Access Compliance Report

Public Rights-of-Way

(Curb Ramps)

Intersection ID: 15013	Main Street: E_WORTHINGTON_AV	Cross Street: EWING_AV	Location: N
ADA ID: 541DFE550EBD	Ramp Type: Perp	Initial Pass/Fail: Fail	Overall Compliance: No
Severity Score: 33.75			
Codes/Mitigation Info/Possible Solution		Field Measurements/Component Compliance

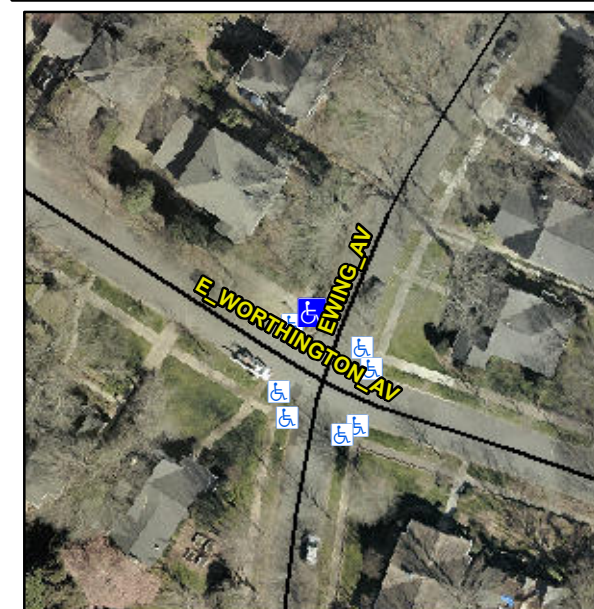
Not Found, R304.5.1, R304.2.2, R304.5.3

Compliance	Description	Data	Compliance	Description	Data
N/A	Ramp Length (in)	82.0	No	Ramp Slope (%)	9.5
No	Ramp Width (in)	36.0	No	Ramp XSlope (%)	5.2
N/A	Flare Type LT	N/A	N/A	Flare Type RT	N/A
N/A	Flare Slope LT (%)	N/A	N/A	Flare Slope RT (%)	N/A
N/A	Flare Traversable LT?	N/A	N/A	Flare Traversable RT?	N/A
N/A	Landing Length (in)	N/A	N/A	DWS Provided?	N/A
N/A	Landing Width (in)	N/A	N/A	DWS Contrast?	N/A
N/A	Landing Slope (%)	N/A	N/A	DWS Length (in)	N/A
N/A	Landing X Slope (%)	N/A	N/A	DWS Full Width?	N/A
N/A	Landing Curb? (Y/N)	N/A	N/A	DWS Offset (in)	N/A
N/A	Shared Landing?	N/A			
N/A	Gutter Ponding?	N/A	N/A	Gutter Slope (%)	N/A
N/A	Gutter Lip Ht (in)	1.0	N/A	Gutter X Slope (%)	N/A
N/A	Painted X Walk1?	No	N/A	Painted X Walk2?	N/A
	X Walk 1 Direction	To SE		X Walk 2 Direction	N/A
N/A	X Walk 1 Width (in)	N/A	N/A	X Walk 2 Width (in)	N/A
	X Walk 1 Slope (%)	1.4		X Walk 2 Slope (%)	N/A
	X Walk 1 X Slope (%)	0.9		X Walk 2 X Slope (%)	N/A

Remove & Replace Entire Ramp.
